Re: Initial Submission Review – Green Valley Ranch East Site Plan No. 18 - Site Plan and Plat
Application Number: **DA-1662-30**
Case Number(s): 2022-4023-00; 2022-3058-00

Initial Submission Review

GREEN VALLEY RANCH EAST SITE PLAN #18

TYPICAL CARRIAGE HOUSE MOTORCOURT SETBACKS

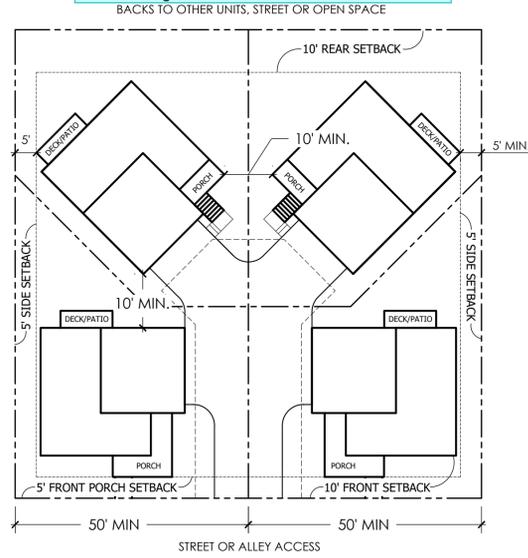
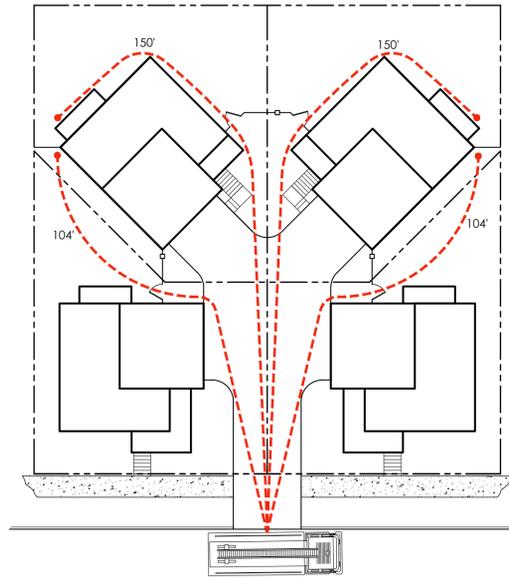
Are there any 4 pack carriage house lots? If not, please delete these details. If there are, see comments on 6-packs and apply to these diagrams.

Tract F to become future 4 Pack carriage house lots with the approval of the CLOMR

LOT DATA TABLE AND SETBACK TAB this should be shown on Sheet 4

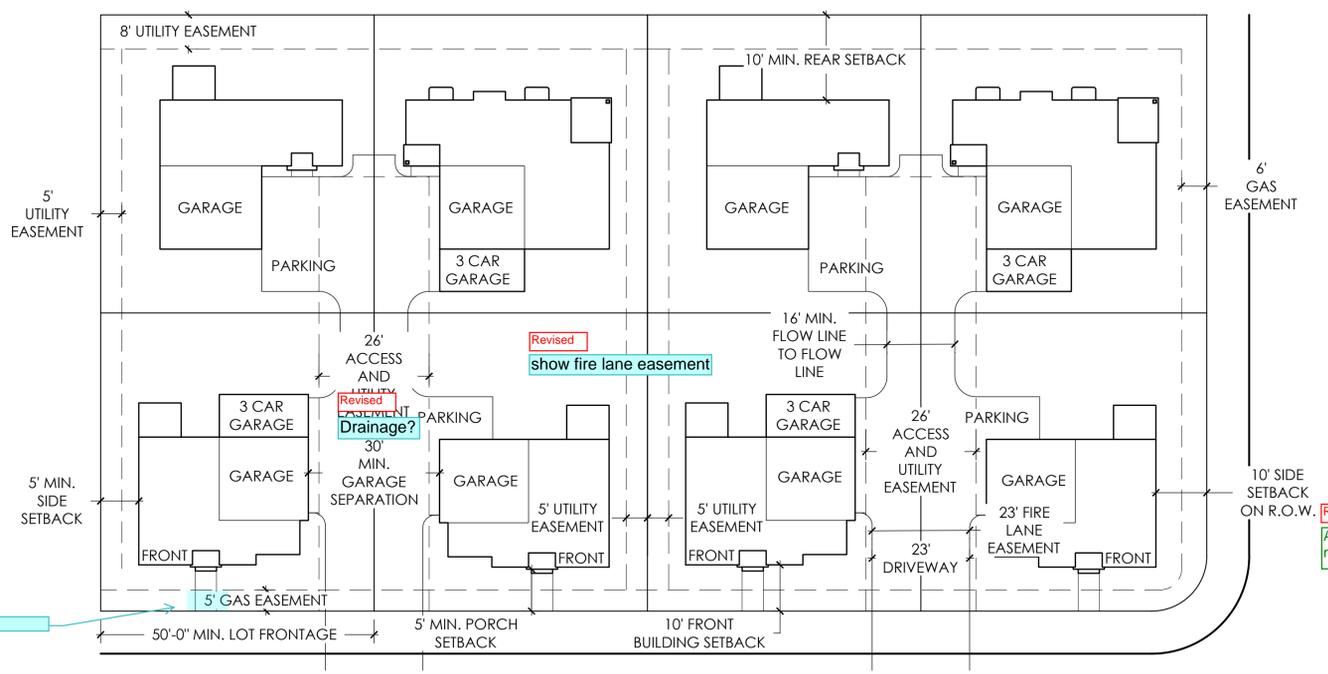
must have street frontage to be considered standard
Revised

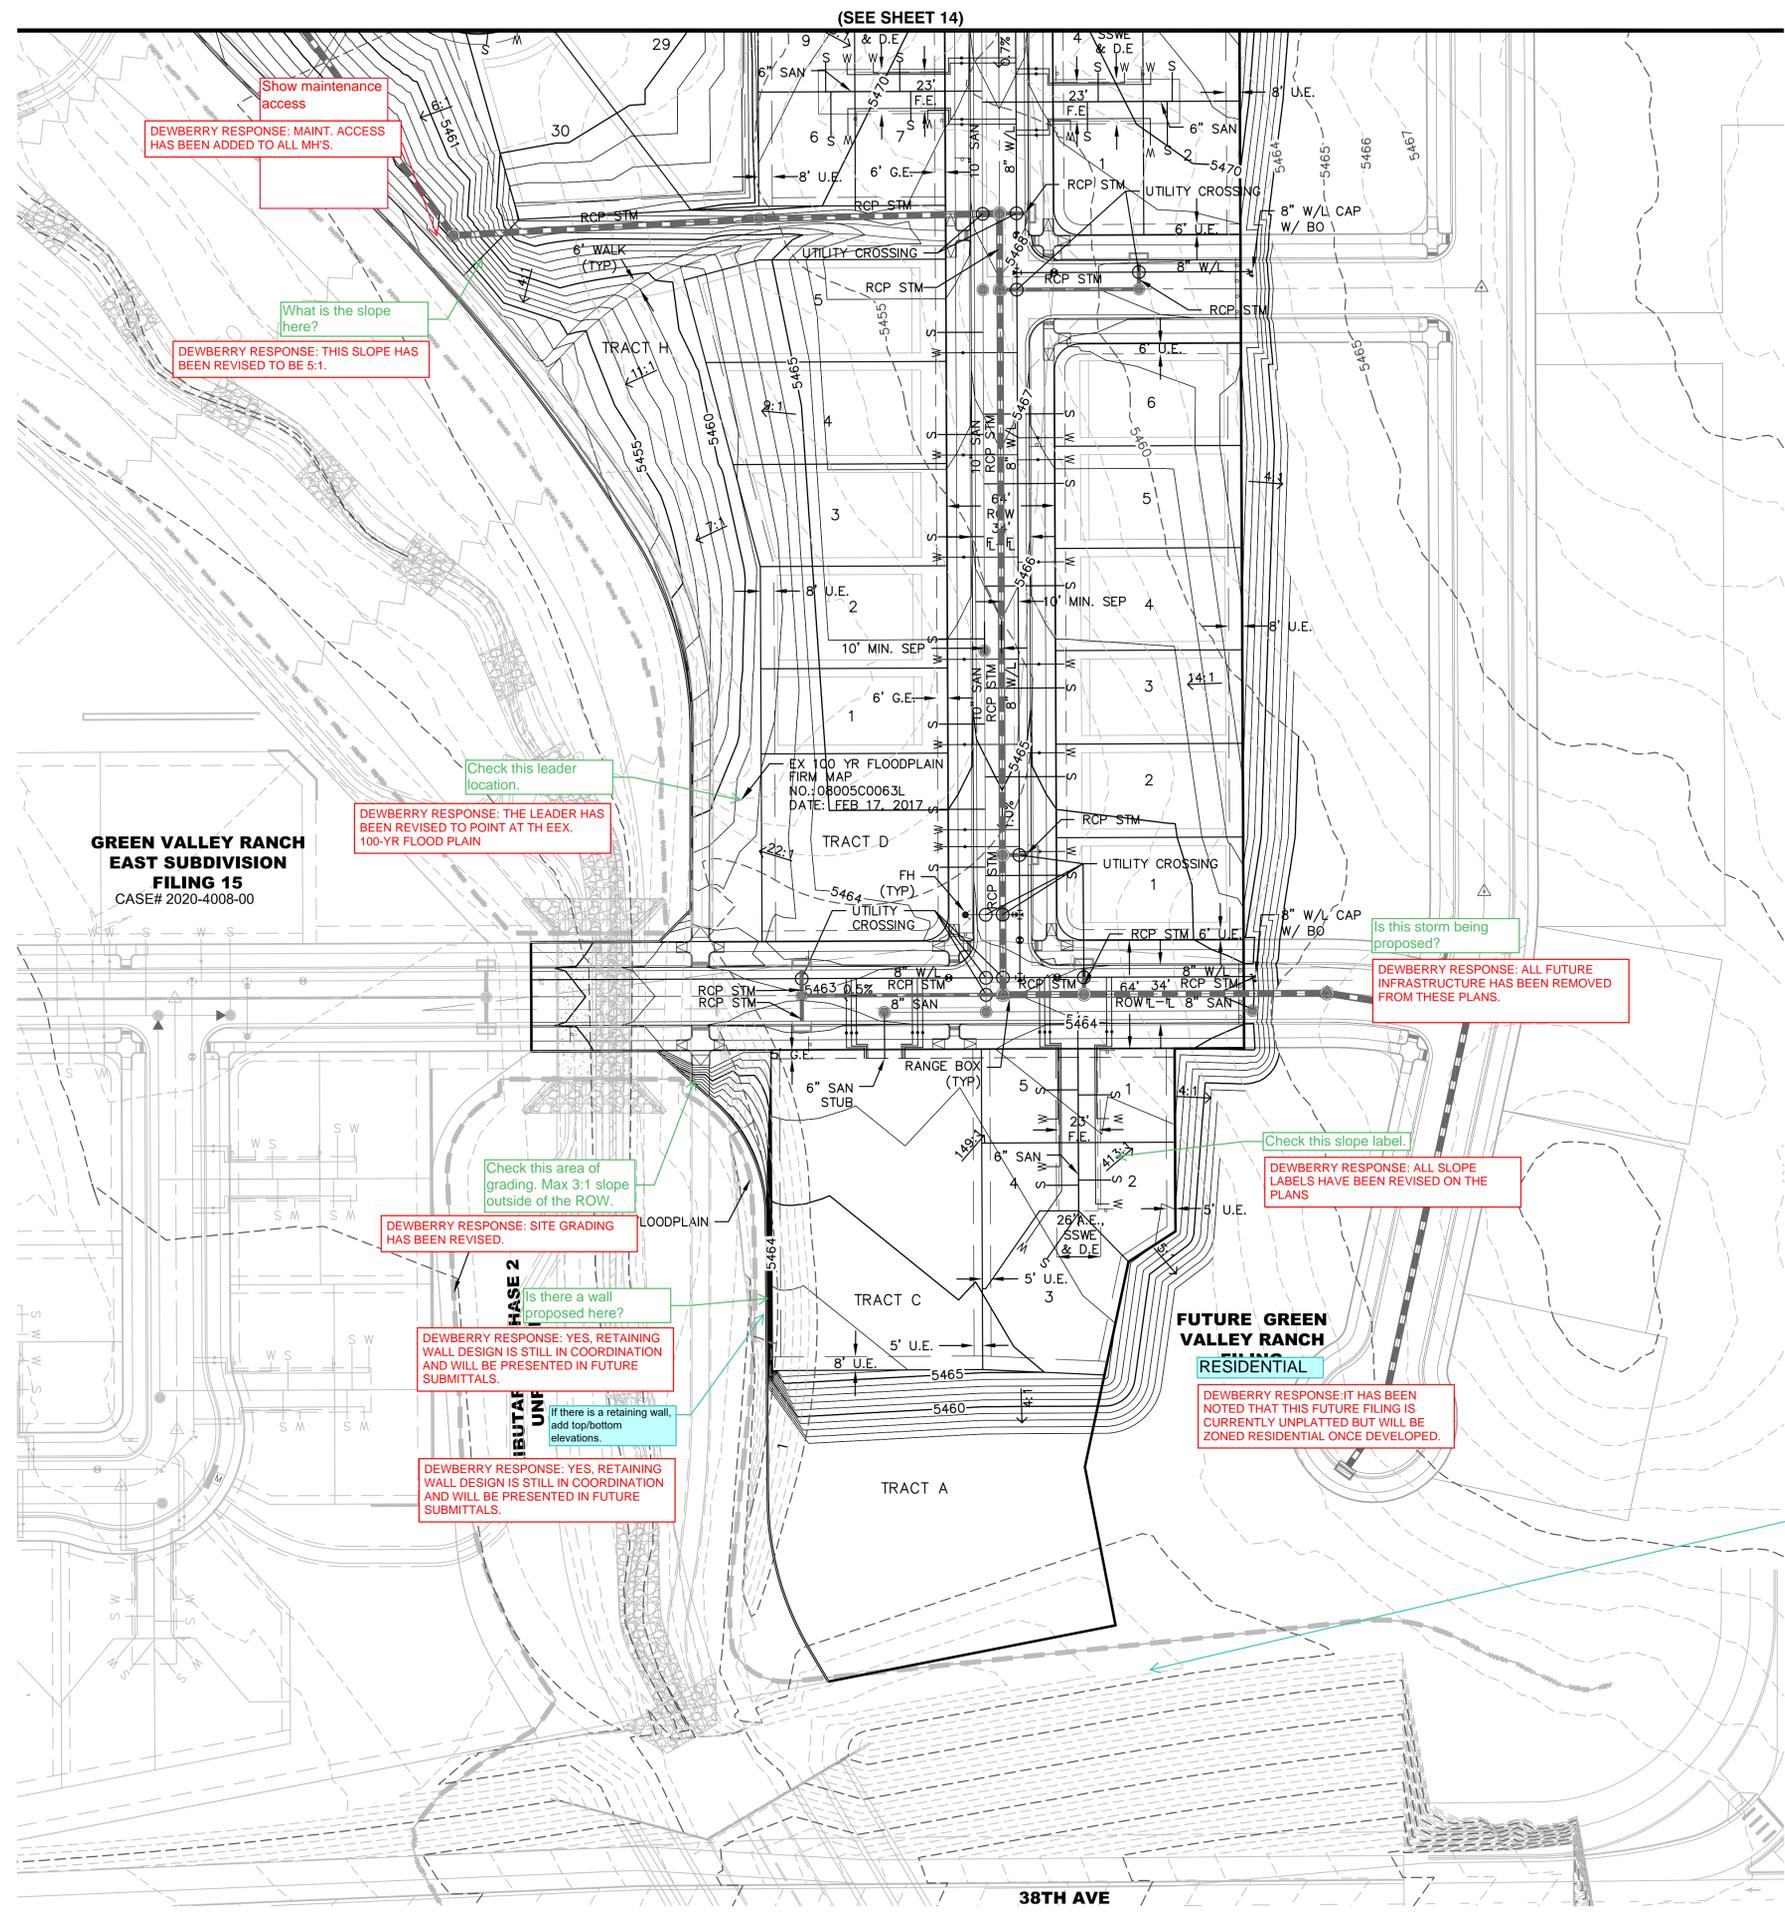
Show maintenance access
DEWBERRY RESPONSE: MAINT. ACCESS HAS BEEN ADDED TO ALL MH'S.

SIGN LEGEND:

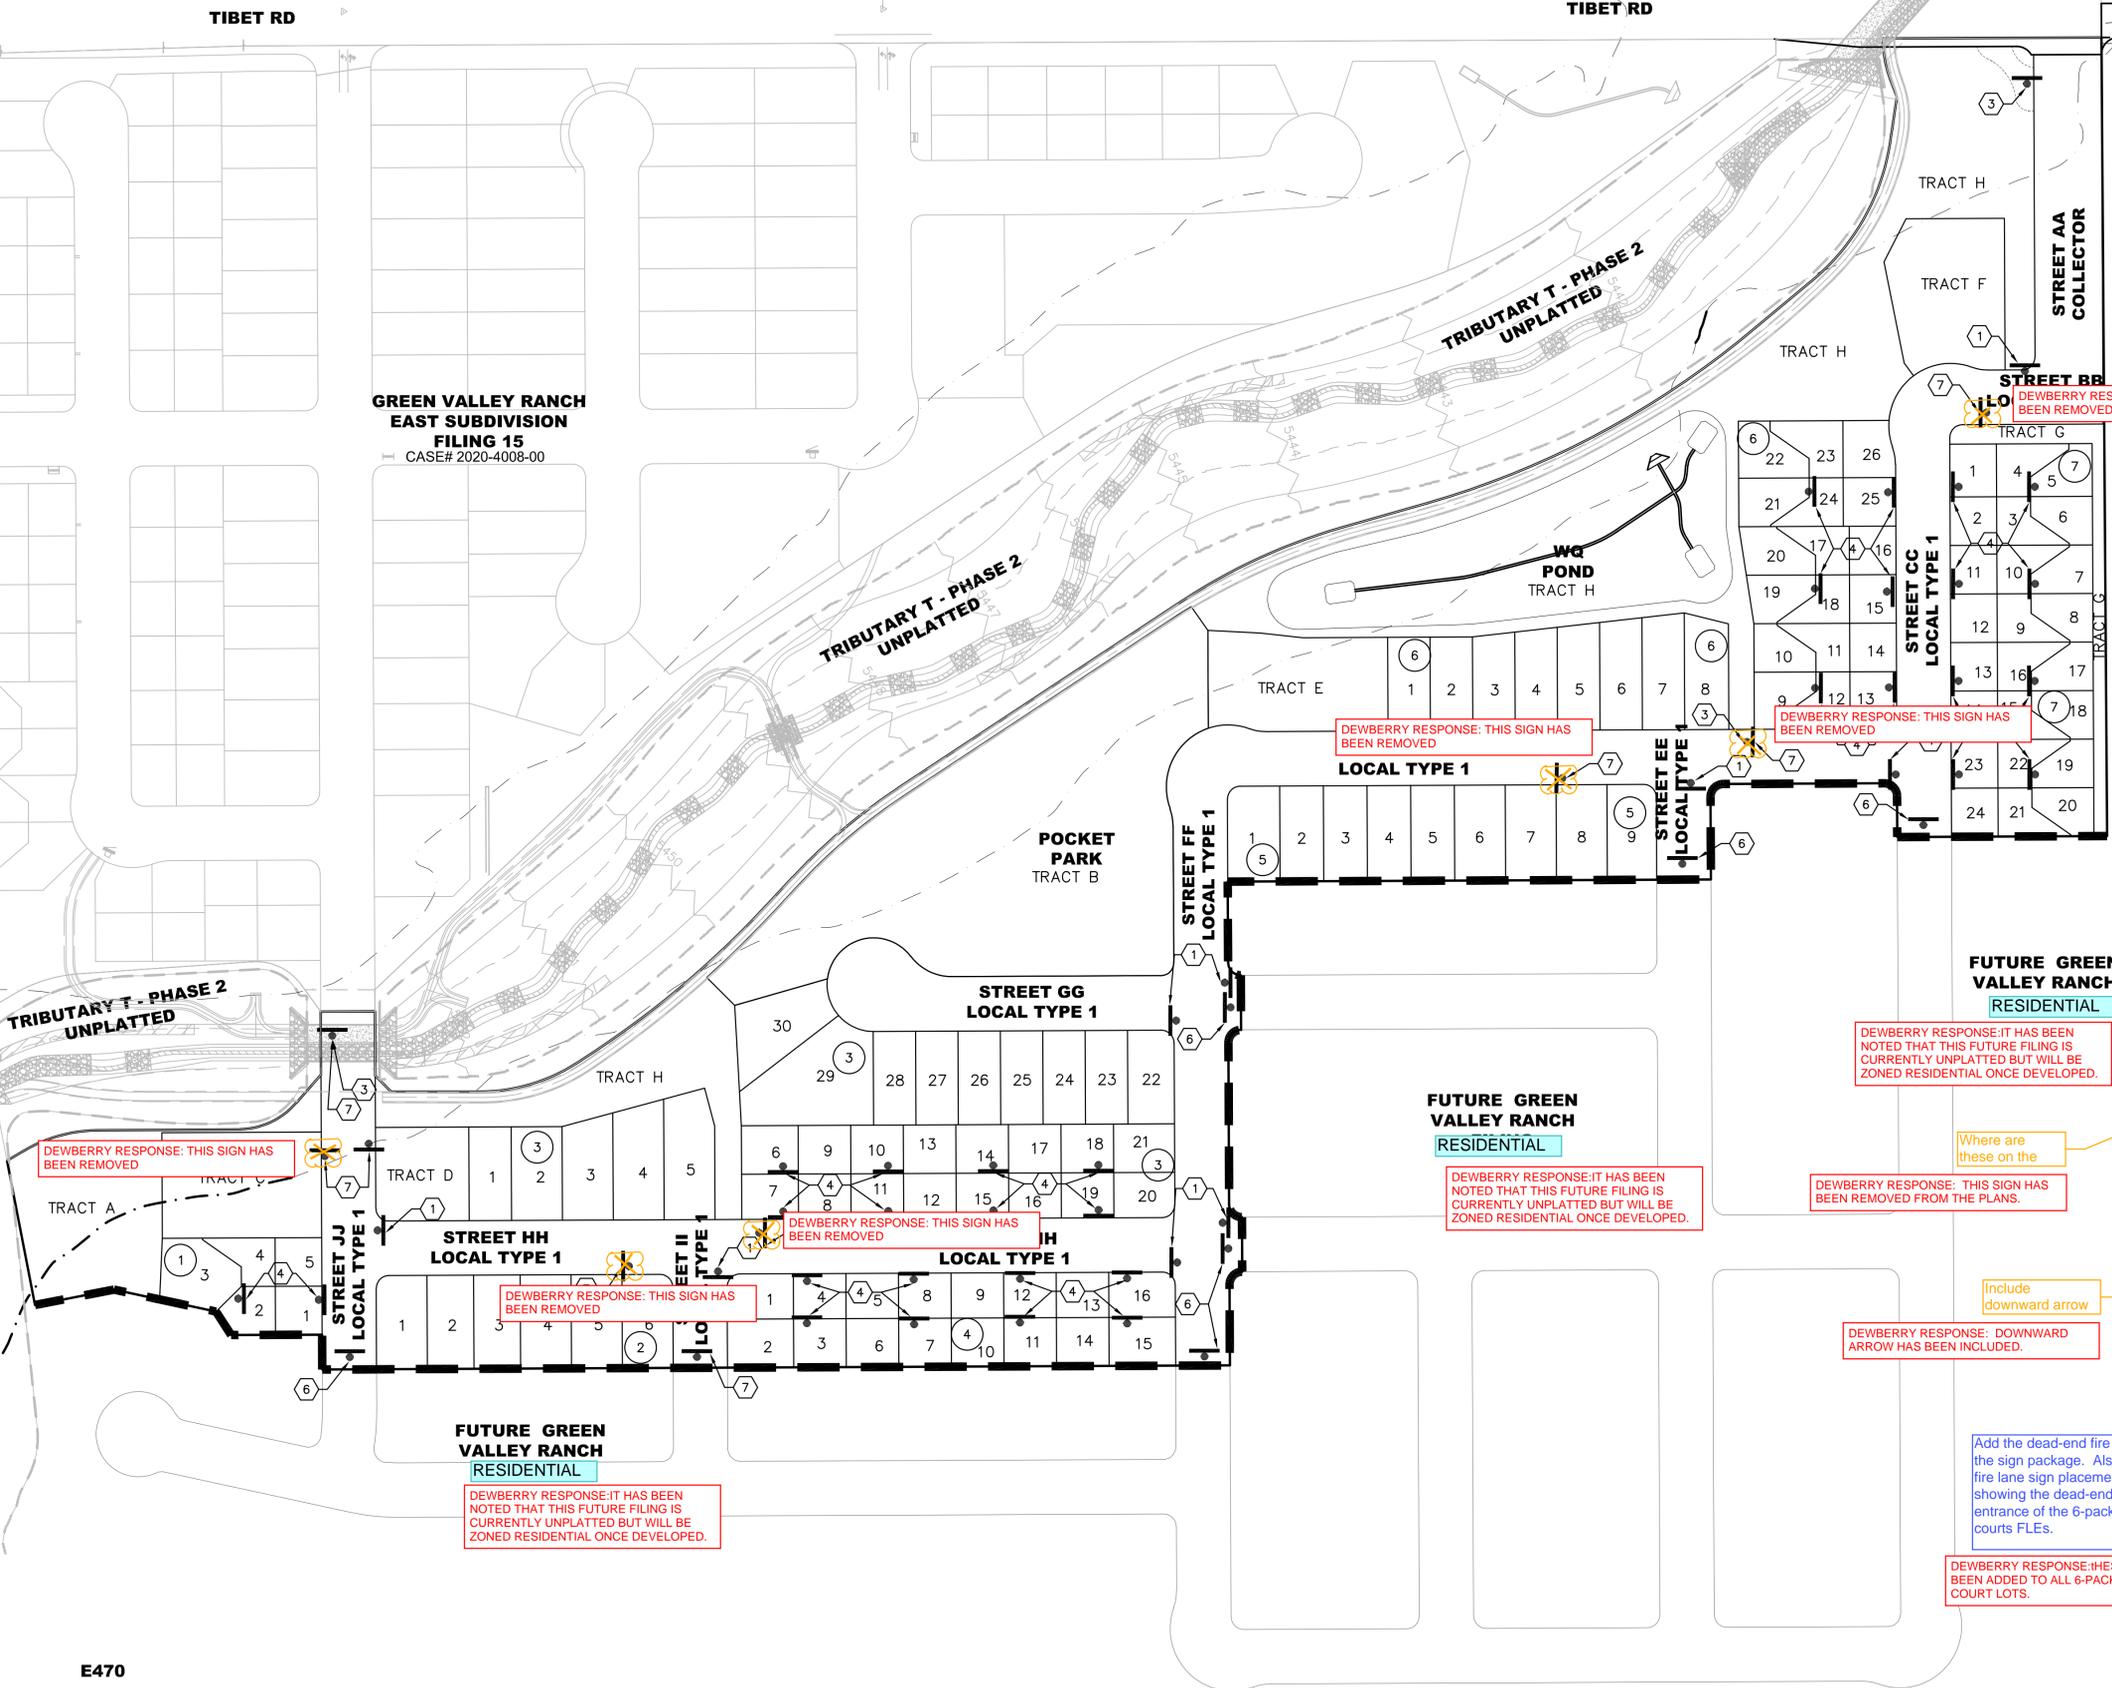
Remove since not being used

Provide dimensions

DEWBERRY RESPONSE: THESE SIGN DIMENSIONS HAVE BEEN LABELED ON PLANS.

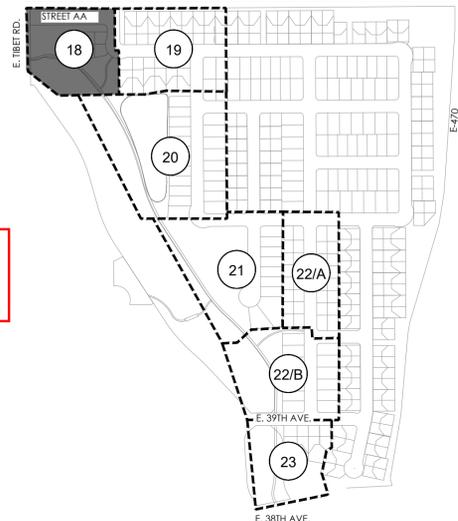
what is planned for Tract F? why does it have a privacy fence and not the open style fence?

These are future lots that will be platted once the CLOMR is approved

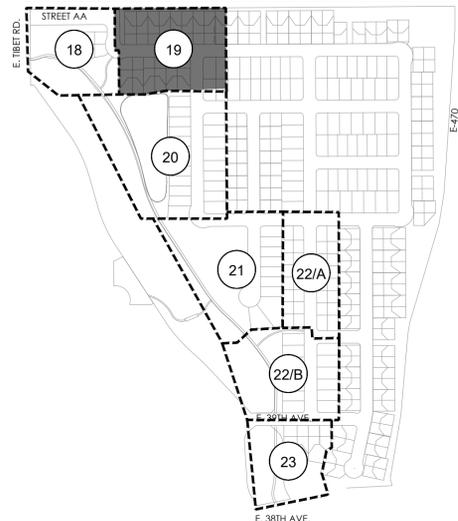
there should be one more tree in this segment

Road network redesigned
